206 C43 AMG - Speakers/front bass in the footwell not functioning (without SA810)

Topic number	LI82.62-P-079964
Version	1
Function group	82.62 - Loudspeakers, amplifiers, antennas
Date	11/3/25
Validity	206 C43 AMG - 206.087 & 206.287 - without SA 810
Reason for change

Attachments	
File	Description
Stecker Typ A Standard Soundsystem.png	Marking the locking mechanism to be removed

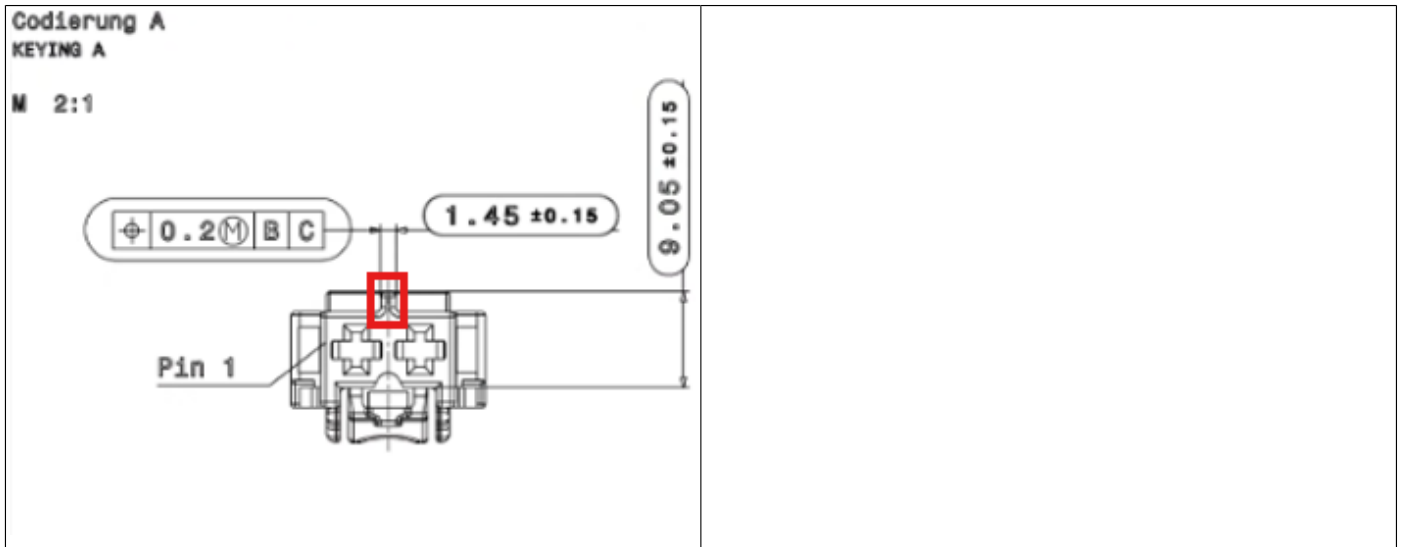
In some cases, the locking mechanism of the plug must be reworked. To do this, remove the area marked in red in the attachment using a suitable tool.
